STAR JUNCTION No.2 DAM
WILLIAM McCORMICK

PHASE I INSPECTION REPORT
NATIONAL DAM INSPECTION PROGRAM

STAR JUNCTION NO. 2 DAM
FAYETTE COUNTY, COMMONWEALTH OF PENNSYLVANIA
NDI NO. PA 00212
PennDER NO. 26-31

Date: 11 April 1980

PHOTO 10. CLOSE-UP OF OUTLET WORKS CONTROL BOX

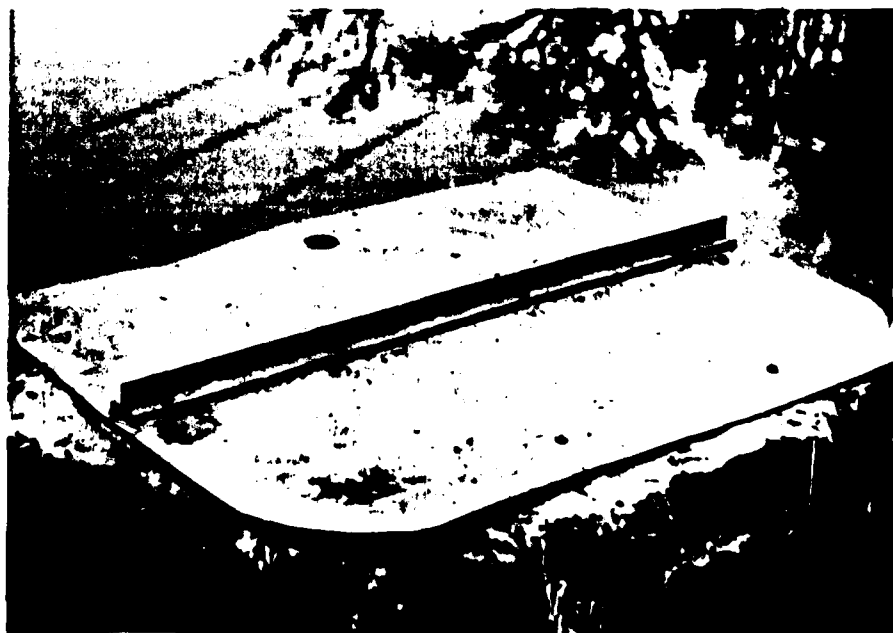
e. Outlet Works: The only visible evidence of an outlet works facility was a steel plate covered masonry structure at the toe of the embankment. The structure was partially inundated by the lower lake. A (valve) stem and associated bracing, all badly bent, were observed inside the structure; operation was not possible.

b. Outlet Works: Visual observations were insufficient to determine the condition or even the existence of the outlet works facility. No mechanism or device for upstream flow control was observed.

(c) Investigation of the outlet works with specific recommendations on making it operable and including provisions for upstream flow control.
